**SUBDIVISION REVIEW SHEET****CASE NO.:** C8-2020-00038.0A**COMMISSION DATE:** July 7, 2020**SUBDIVISION NAME:** Charro Estates, Resubdivision of Lot 15**ADDRESS:** 694 Mesa Drive**OWNER/APPLICANT:** Jocelyn Fuentes**AGENT:** ATX Permit & Consulting, LLC (Lila Nelson)**EXISTING ZONING:** None**JURISDICTION:** 5-Mile ETJ**GRIDS:** S-9**COUNTY:** Bastrop**AREA:** 5.418 acres**LOT(S):** 5**WATERSHED:** Cedar Creek**DISTRICT:** N/A**PROPOSED LAND USE:** Single Family

**EXHIBIT C**CITY OF AUSTIN –DEVELOPMENT SERVICES DEPARTMENT  
SUBDIVISION APPLICATION – MASTER COMMENT REPORT

CASE NUMBER: C8-2020-0038.0A  
 REVISION #: **00** UPDATE: U1  
 CASE MANAGER: Sylvia Limon PHONE #: 512-974-2767

PROJECT NAME: Charro Estates (W/R C8-2019-0031.0A)  
 LOCATION: 694 MESA DR

# CHARRO ESTATES RESUDVISION PLAT OF LOT 15

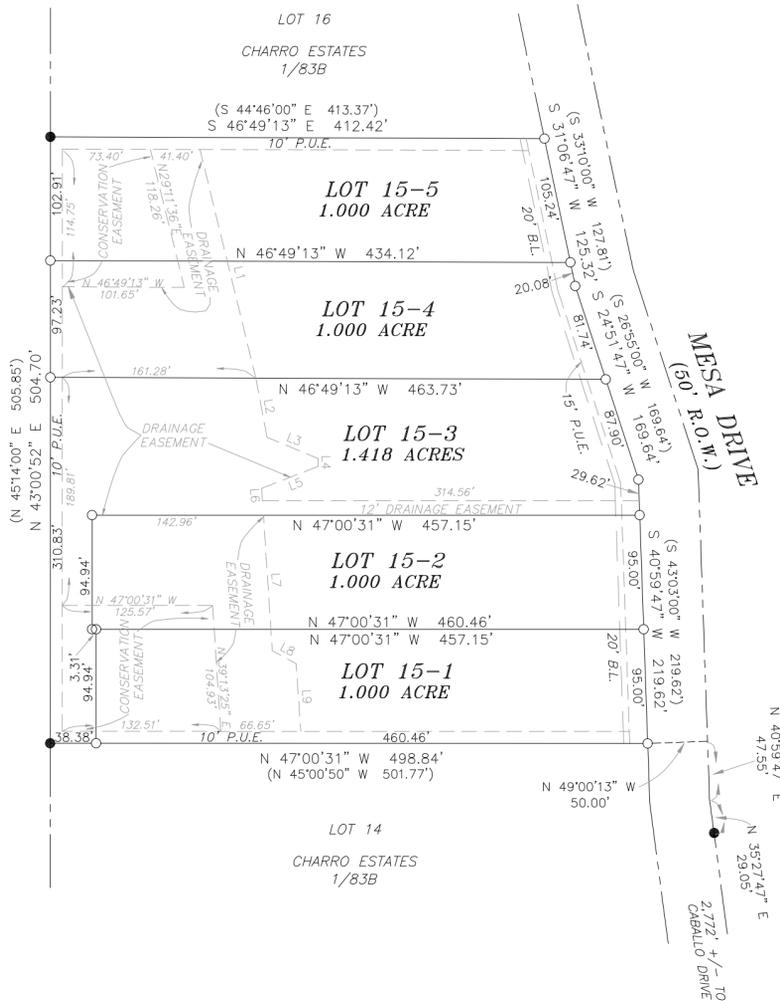
PR 2: Update note 11 on the plat:

A fee-in-lieu of parkland dedication and park development has been paid for 4 residences. No fee was charged for the existing residence.

Comments cleared. The R table will not be needed on the plat itself. This can be removed and the R table can be included in the plans that the pond is built with.

SR 3. If the drainage easement is being created with the plat, be sure show survey boundary information for the boundary of the easement. It appears there are not corresponding measurements for all of the boundary lines of the easement. [LDC 25-1-83]

SR 6. Revise the City of Austin Commission approval block to appear as follows on the plat [LDC 25-1-83]:

**UPDATE #1:** Revised commission block acknowledged. Please make slight correction to COA approval by removing "Acting" after Denise Lucas. Also remove "James E. Garon" from line for "Printed Name of Notary." (unless he is the notary as well as surveyor).

**U1: Cleared.**

**UPDATE #1:** Acknowledged that measurements are now noted on plat. Will defer to drainage engineer reviewer on addressing easements.
